**RE: DCI2020-00010 Lee County Homes Insufficiency Letter
Lee County Homes Associates I, LLLP (MDA 19079)**

The purpose of this letter is to provide a response to the Lee County Community Development Zoning Staff review comments dated September 28, 2020 for the above referenced Residential Planned Development application. Attached to this response letter please find; a copy of the revised survey, the letter received from the South Florida Water Management District regarding wetland locations as well as a revised Schedule of Deviations further justifying deviation number 2.

BOUNDARY SURVEY

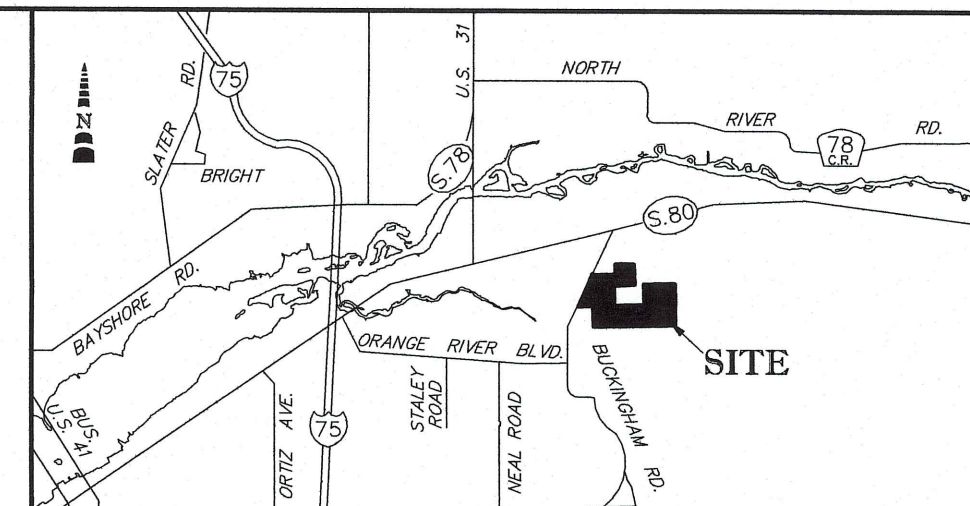
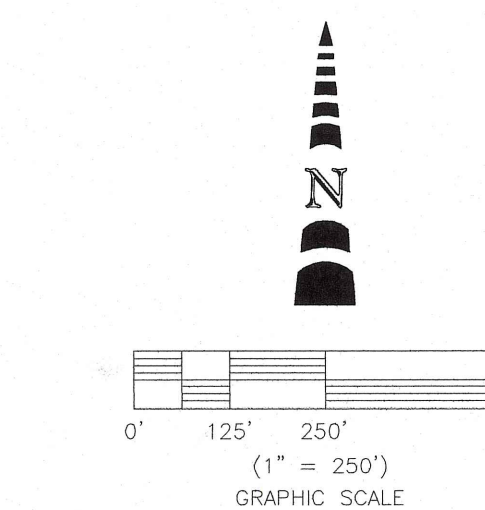
1. The boundary survey is still based upon previously insufficient title work, rather than the newly submitted title opinion. The survey must also be signed/sealed.
- 2.

The revised boundary survey is enclosed.
